MEMORANDUM

DATE: April 17, 2019
TO: City of McMinnville - Planning Department, City Attorney
FROM: Ron Pomeroy
SUBJECT: Errata RE: PDA 3-18, PDA 4-18 and S 3-18 Staff Report and Decision Documents

Errata

EXHIBIT 6

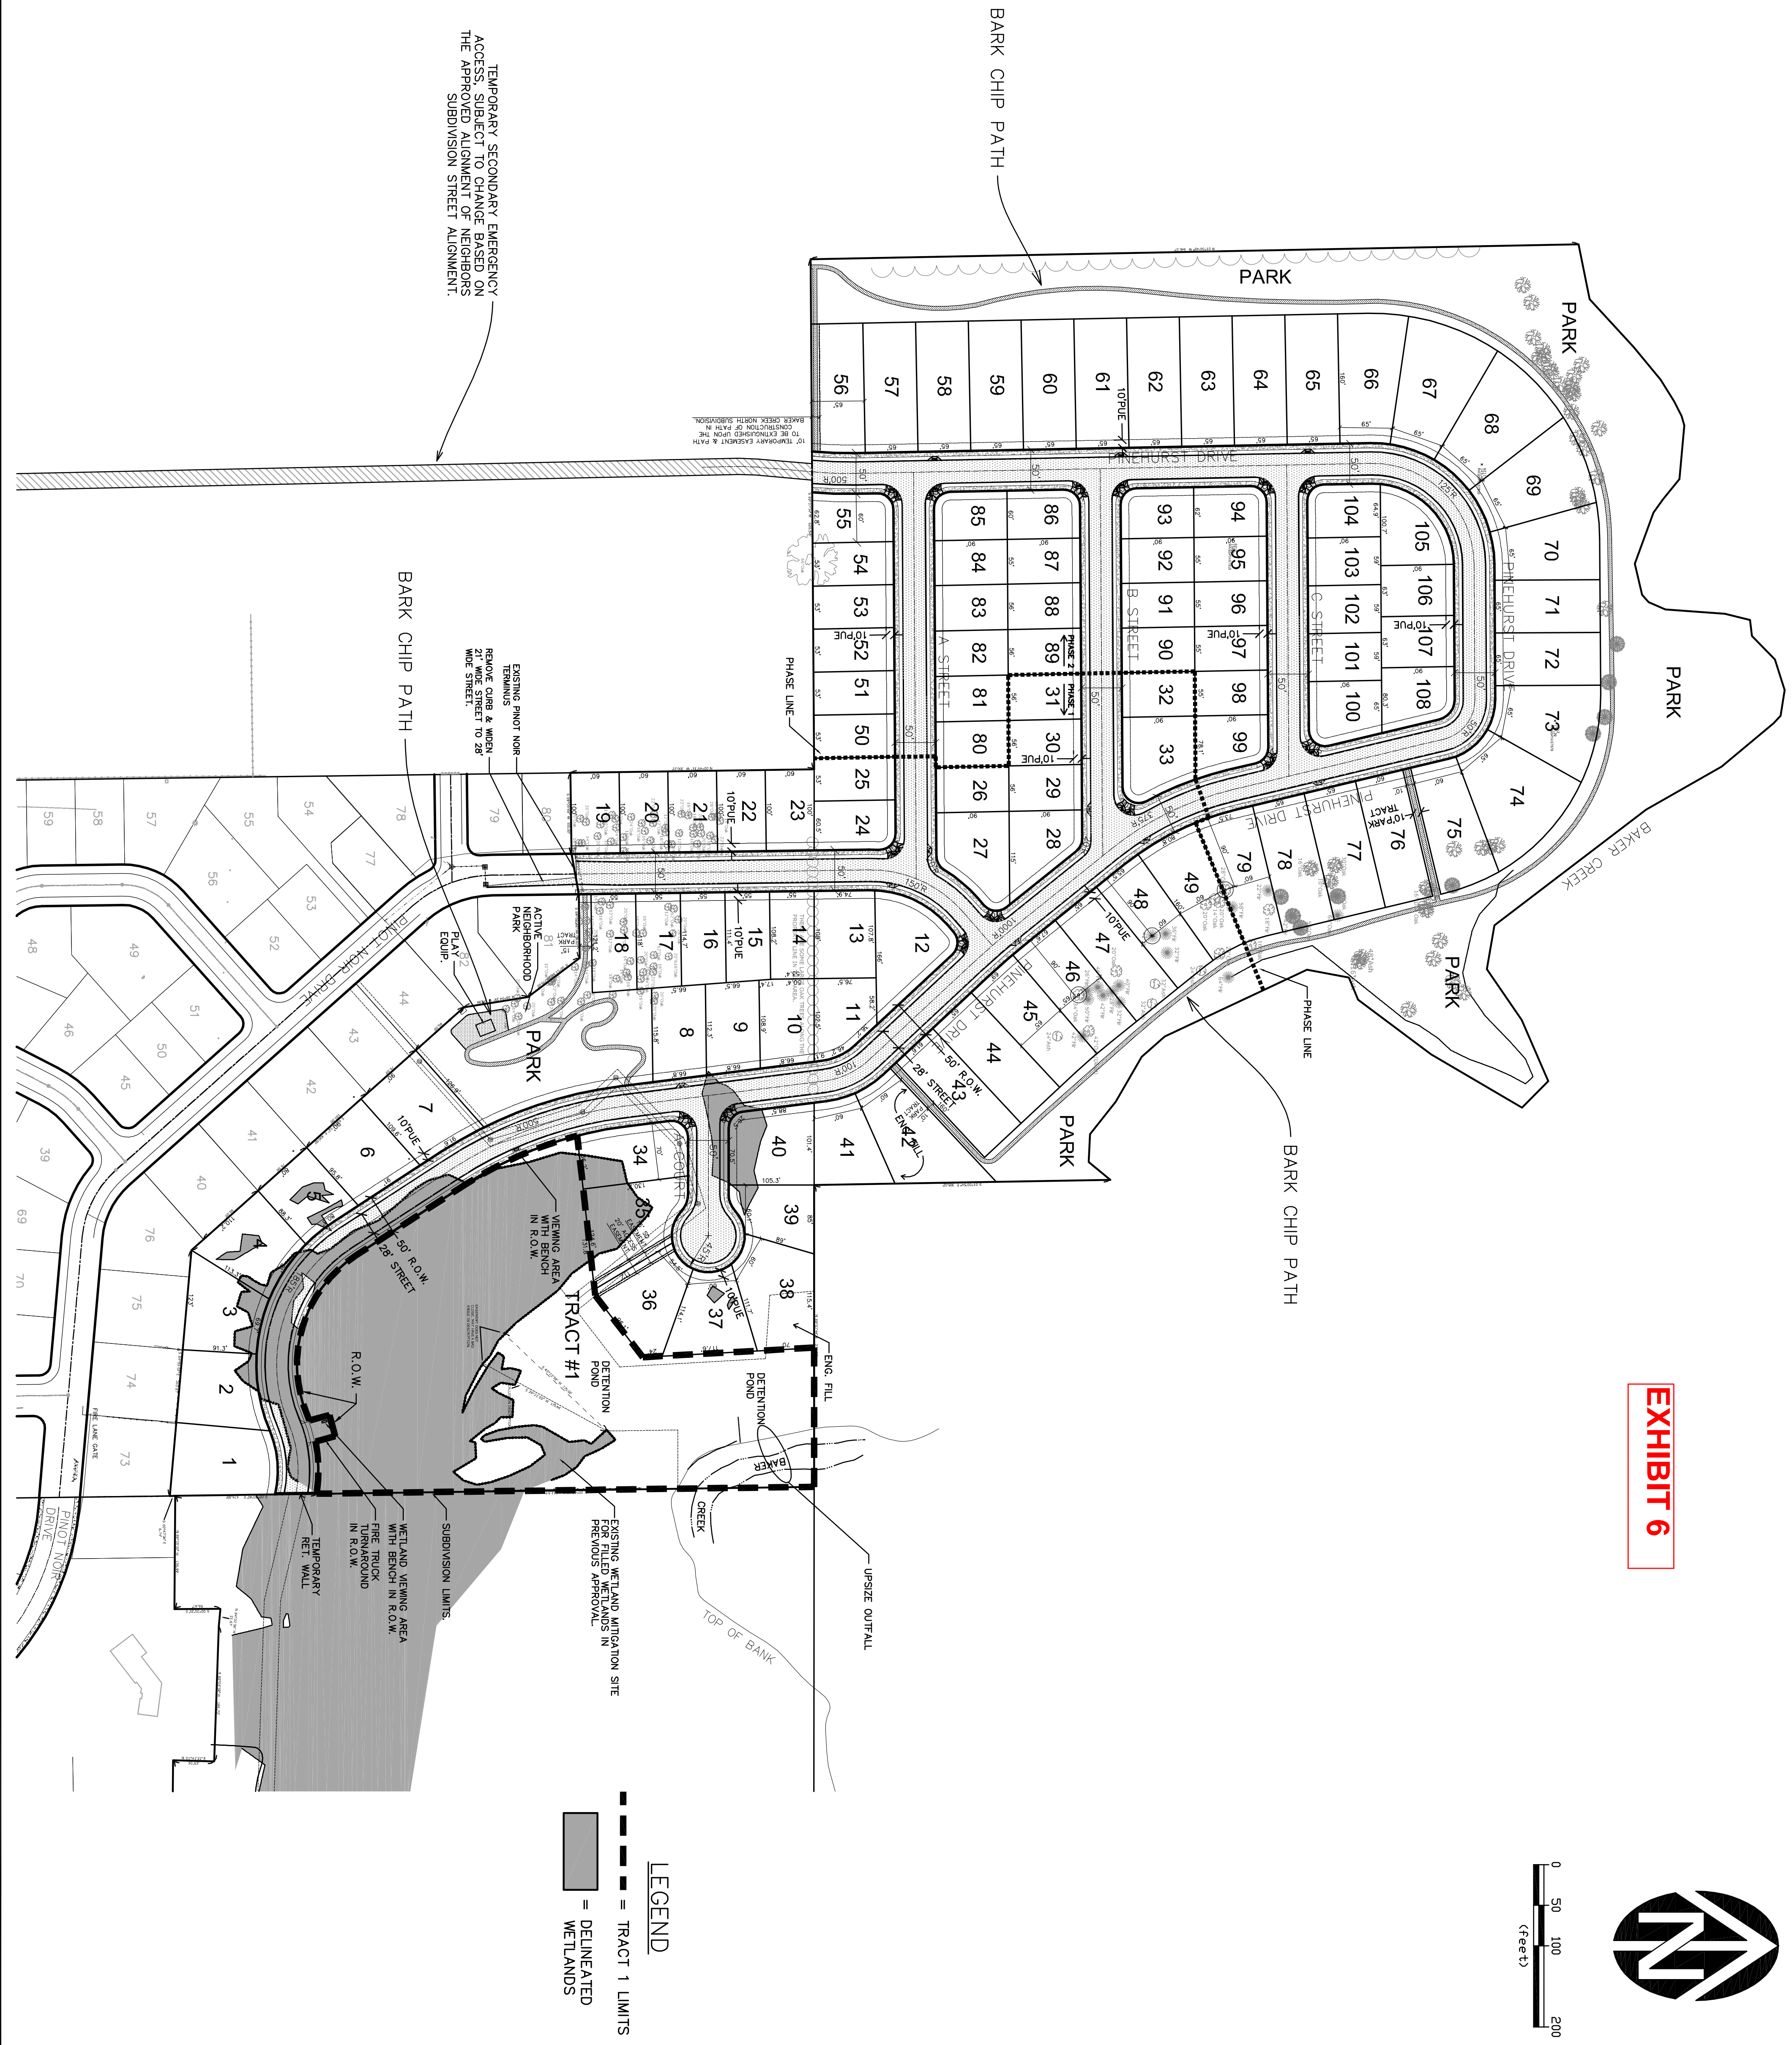
We think the reference to viewing benches being located in Tract 1, is mistaken. Neither proposed wetland viewing benches are proposed to be located within Tract 1 and it is not clear that we could obtain permission from DSL to put them in Tract 1. Rather, the viewing benches are proposed to be located outside the Tract 1 wetlands and within the adjacent right-of-way. We recognize that the difference in line types and the shading provided on Exhibits 6, 9 and 11, may make it unclear where

Tract 1 is located. Included with this memo is an amended Exhibit 6 graphic to more clearly differentiate the location of Tract 1.

We suggest that Condition 10 of PDA 4-18, be amended as follows (underlined is new):

“That the majority of delineated wetland be preserved, and a minimum of two (2) wetland viewing areas that are accessible with seating be provided adjacent to the wetlands ~~inside~~ outside the common open space Tract 1.”

Similarly, we suggest that the portion of Condition 3 of S 3-18, be amended to read:

“Improvements in the wetland viewing areas in ~~Tract 1~~ the right-of-way and the fire truck turnaround shall include, at a minimum, appropriate seating and trash/recycling collection.”
